Holcim (Australia) Pty Ltd
Dunloe Sands Quarry - Modification to Project Approval 06/-
0030
Submissions Report

November 2017

Absorption capacity 2017

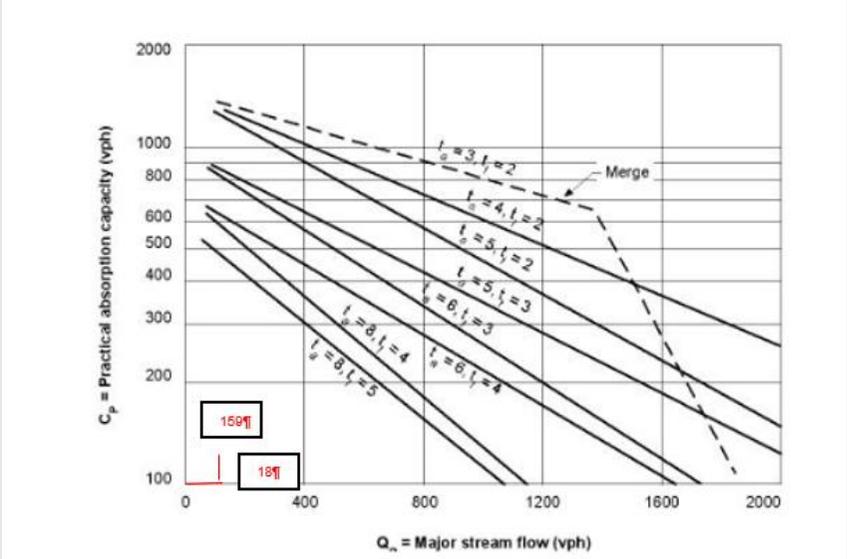
<p>Roads and Maritime does not support the desktop analysis under Section 4.4 of the TIA. The Pottsville Road and Site Access Road intersection is located in the vicinity of horizontal and vertical curves which appear to constrain sight distances in both directions. The proposed increase in slow-moving heavy vehicles turning at the intersection has the potential to impact on the safety of vehicles travelling along the public road.</p> <p>It is recommended that the Consent Authority require an independent Road</p>	<p>GHD commissioned an independent RSA (Appendix B), which identified a number of proposed mitigation measures to improve safety at the site access intersection, including:</p> <ul style="list-style-type: none"> • Providing new line markings on Pottsville Road in proximity to the access road • Resurfacing damaged sections of road • Providing minimum one metre wide shoulders in accordance with Austroads requirements for rural roads with an (AADT of between 1,000 – 3,000 vehicles/day) • Installing raised reflective pavement markers through the intersection and on approach • Installing guardrails along sections of road to protect against hazards • Replacing all damaged and broken guideposts. <p>The RSA provides a ranking for each recommendation to prioritise importance with respect to the safety of road users.</p>

Based on discussion with Tweed Shire Council, a two percent linear annual growth rate has been applied to the current traffic volumes in order to identify forecast background traffic volumes in the 2027 future horizon year. This is considered to be a conservative estimate of background traffic growth, as traffic data provided by Council indicates that there has been no increase in traffic volumes along Pottsville Road between 2010 and 2013.

Based upon the application of a two percent annual growth rate, by 2027 Pottsville Road is expected to accommodate approximately 200 (two-way) vehicle trips per hour.

Figure 2 – Absorption Capacity (2017)

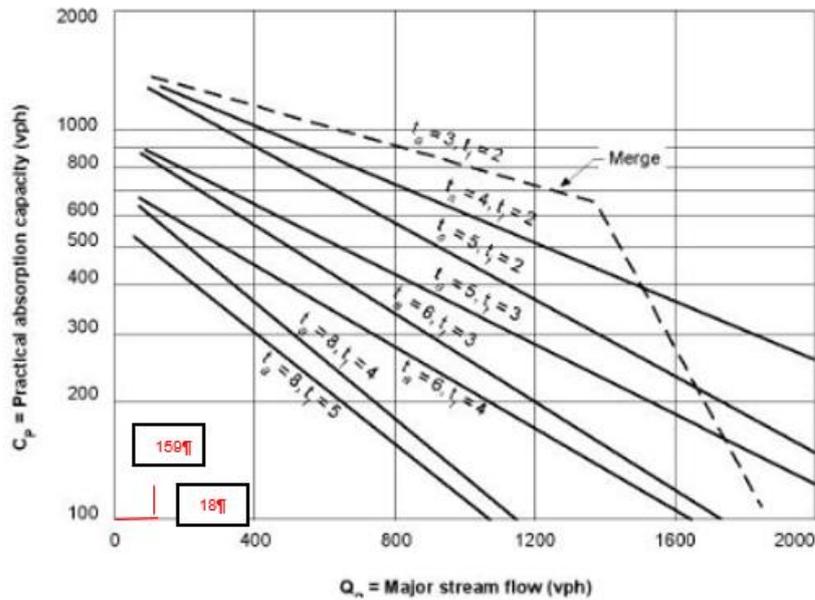
The TIA does not consider the proposed increase in truck movements in the context of future traffic conditions over a 10 year horizon. The TIA should have considered background traffic growth along the identified transport route and the cumulative impact of planned developments in the subject area.

The impacts of the proposed modifications to the operation of the quarry was undertaken utilising absorption capacity analysis (Cp). Absorption capacity analysis determines the maximum rate traffic streams can absorb additional vehicles.

As shown in Figure 2, based on the current peak hour traffic volumes on Pottsville Road of 159 vehicles with up to 18 vehicles exiting the site (assuming 12 trucks and six employees in light vehicles), there is adequate capacity to absorb the additional vehicle movements without additional traffic control.
